Set #1. Two pair of identical gates (4 singles)

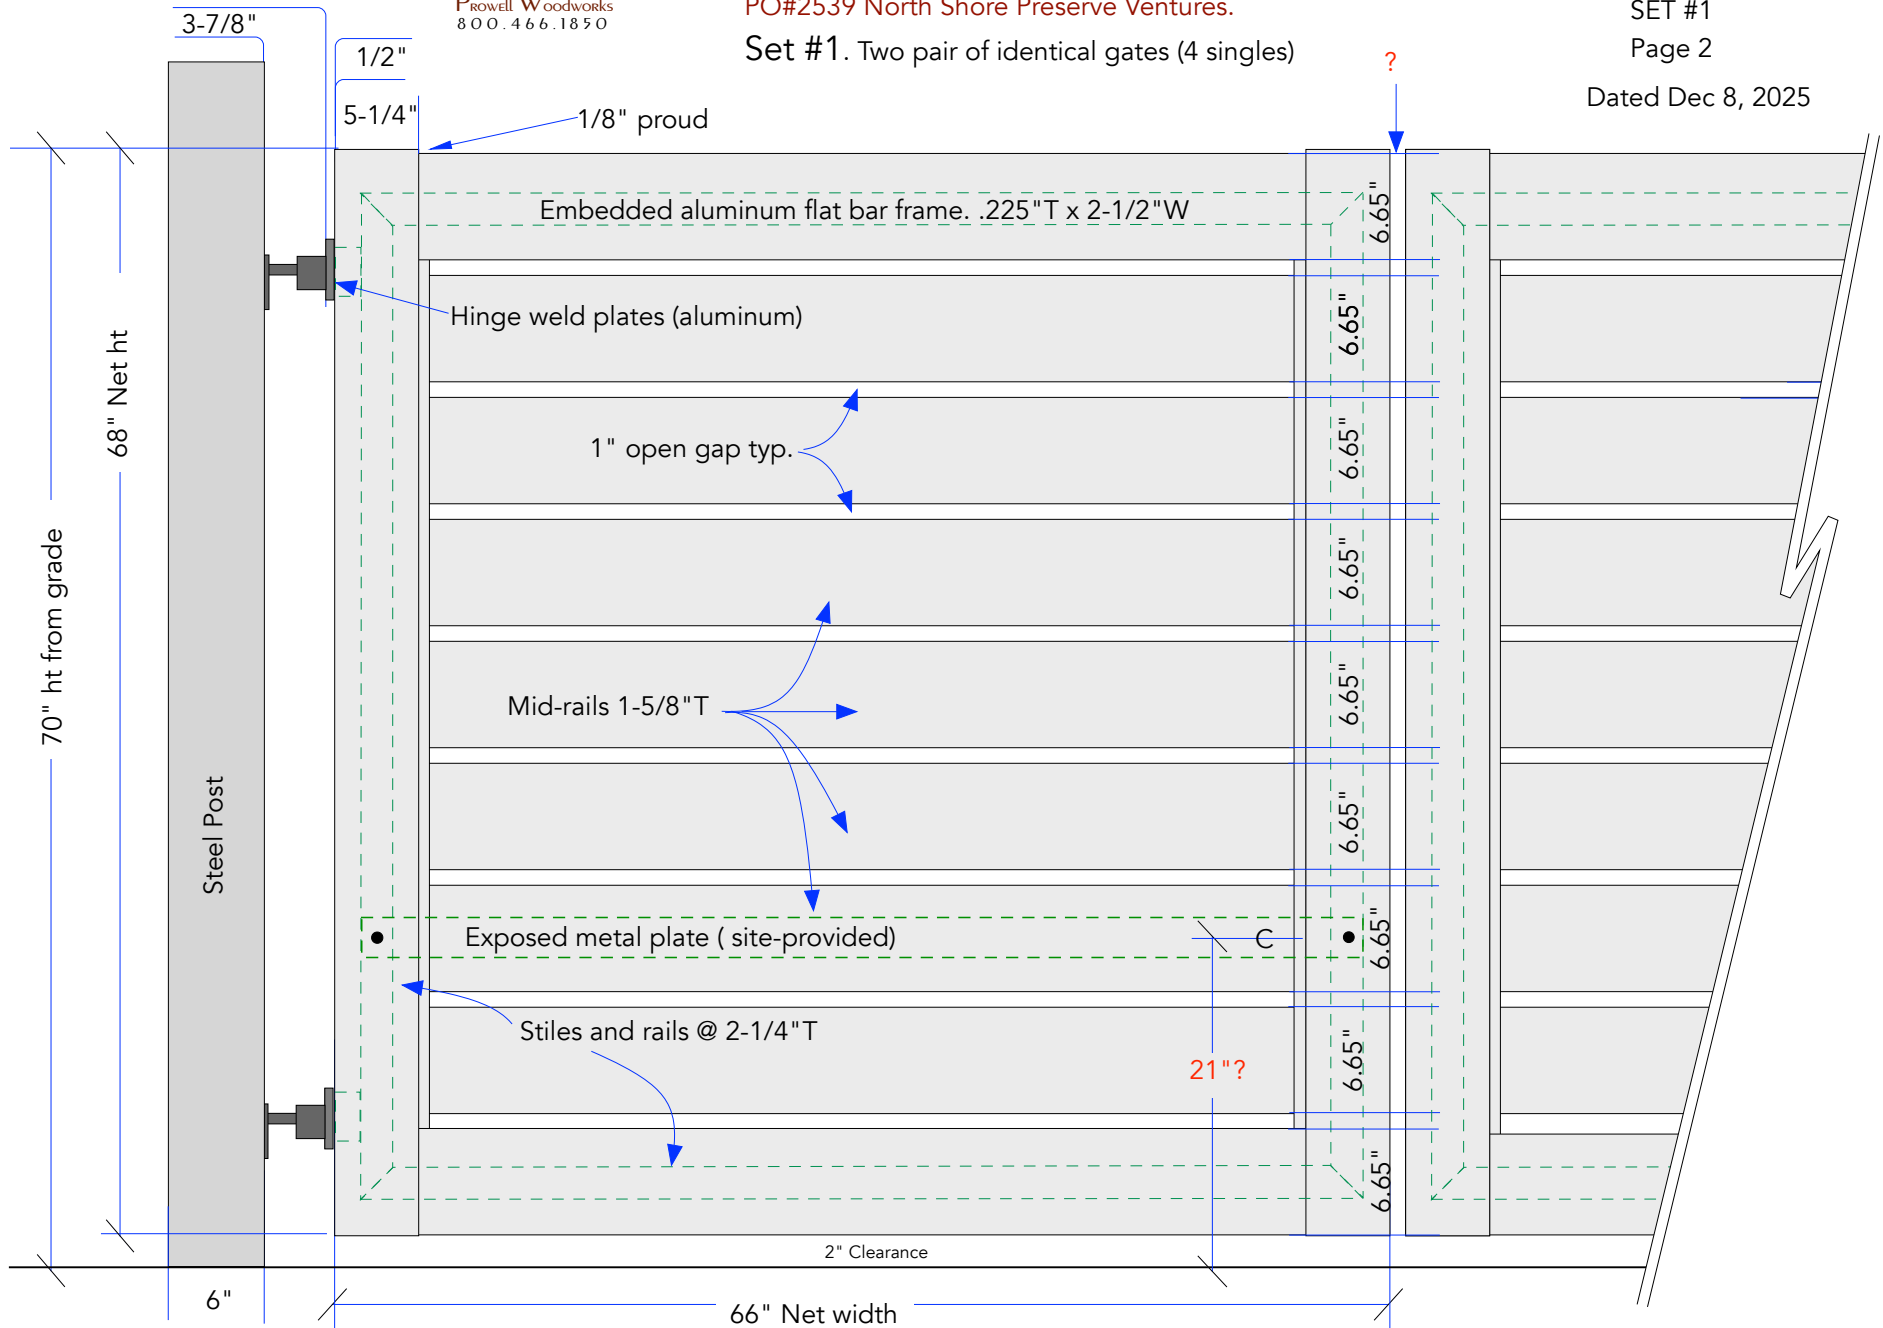
NOTES: Motor arm is at 18-1/2" from grade? Concrete motor footing is formed such that the motor arm mounts to the center of the 3rd rail from the bottom, at 21". (To be field verified)

NOTES: *Embedded frames are centered on stiles and rail widths
* The height placement of the motor-arm mounting plate to be field verified.
